Amendments to the Drawings

Applicant: Daniel J. Durda perial No.: New US Patent Application Filed: April 15, 2004 For: AERATOR Docket: 1015.1126101 Sheet 1 of 3

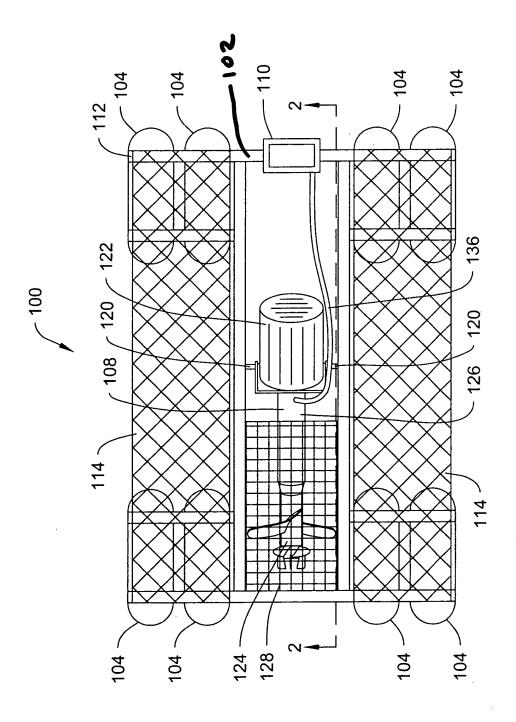
In paragraph 3 of the Office Action, the Examiner objected to the drawings under 37 C.F.R. § 1.84(p)(5) for not including reference signs "102" and "116" mentioned in the Specification. In addition, in paragraph 4 of the Office Action, the Examiner further

objected to the drawings under 37 C.F.R. § 1.84(p)(4) stating that reference character "136" has been used to designate both a flexible hose in Figures 1 and 2 and the primary propeller in Figures 2 and 3. According to the Examiner, corrected drawing sheets in compliance with 37 C.F.R. § 1.121(d) are required in reply to the Office Action in order to avoid abandonment of the application.

In response to these objections, Applicant has submitted herewith three corrected drawing sheets along with a marked-up copy of the old drawings indicating those changes made. In particular, Applicant has amended the drawings to add reference numbers 102 and 116 in Figures 1-2. Moreover, Applicant has changed reference number "136" used to designate the primary propeller in the drawings and the specification to now read "137". Applicant respectfully asserts that these drawing amendments overcome the Examiner's objections to the drawings.
